1 INTRODUCTION

1.2 Highways Response

- 1.2.4 This Highways Note 1 (HN1) presents a revised layout which addresses these issues.

Project	THE BRIDGEWAY CENTRE, SITE 1 WREXHAM INDUSTRIAL ESTATE, WREXHAM, CLWYD
Title	BLOCK F-J INTERNAL SWEEP PATH ANALYSIS - 16.5m ARTICULATED LORRY

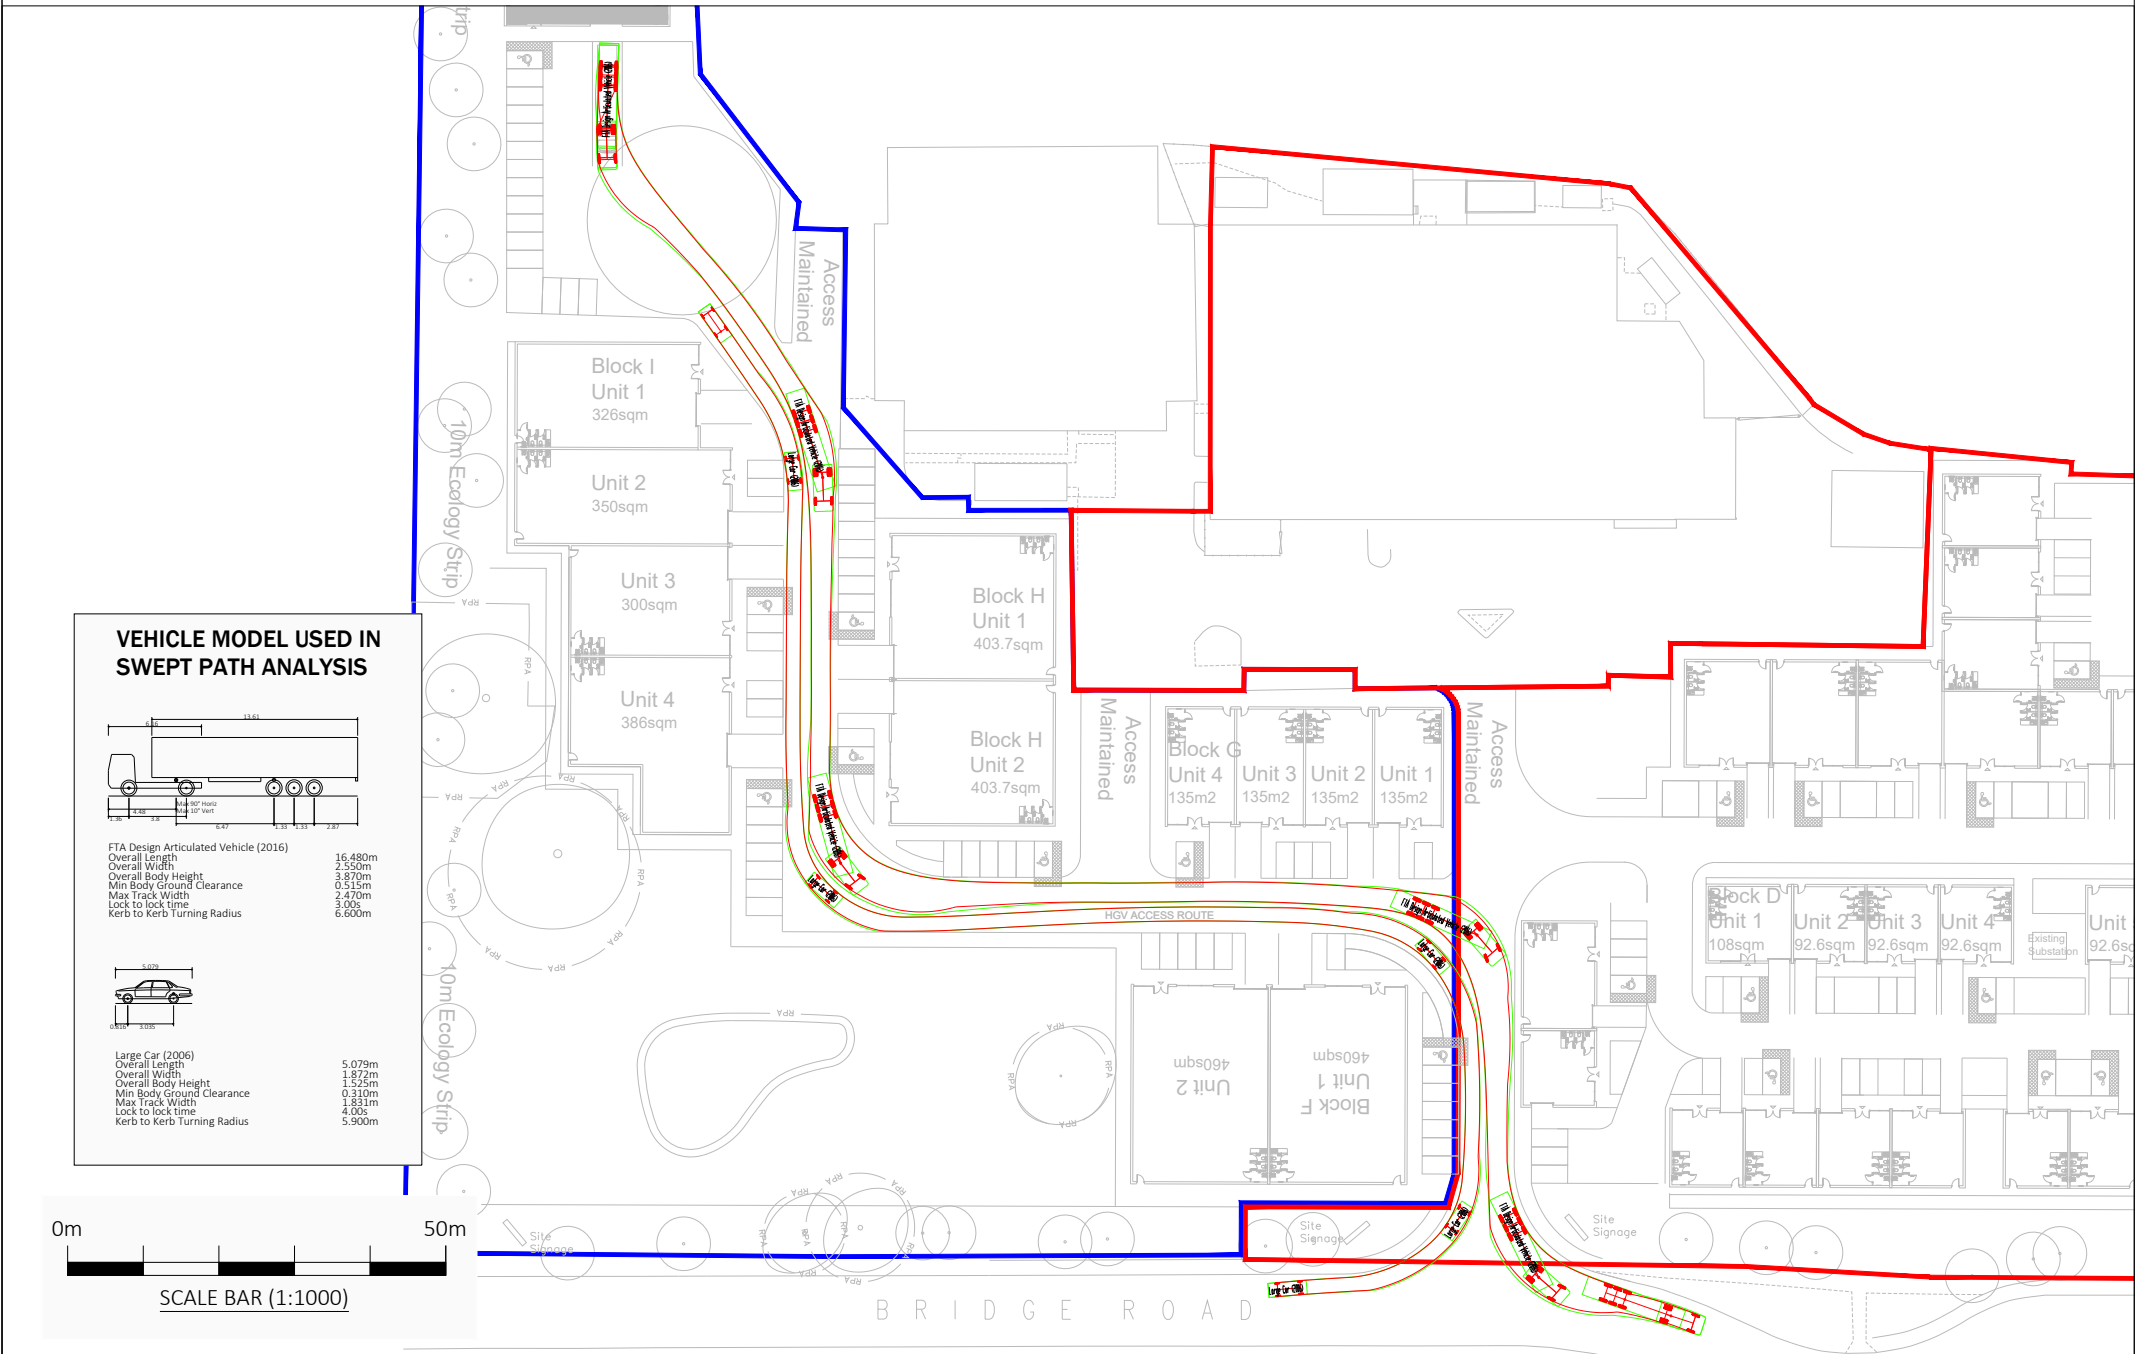
- Site layout with regards to turning heads and circulation at Blocks C, E and F; and
- The number of parking spaces as the proposals exceed the standards of LPG16 by 27 spaces.

- 2.4.1 The swept path analysis previously presented has been updated to reflect the proposed changes to the site layout. The updated swept path analysis is presented in Appendix I of this HN1.
- 2.4.2 Drawing P20030-003C presents the swept path analysis for a large refuse collection vehicle navigating the existing (east of Block B) and proposed internal road layout between Blocks B to E. The vehicle is able to navigate the layout with relative ease and is expected to be the largest vehicle that requires

access to this part of the site on a regular basis. The smaller vehicles, such as cars and vans, that will be the predominant vehicle types accessing this part of the site have less onerous swept paths and will therefore be able to navigate the roads between Blocks B to E with ease.
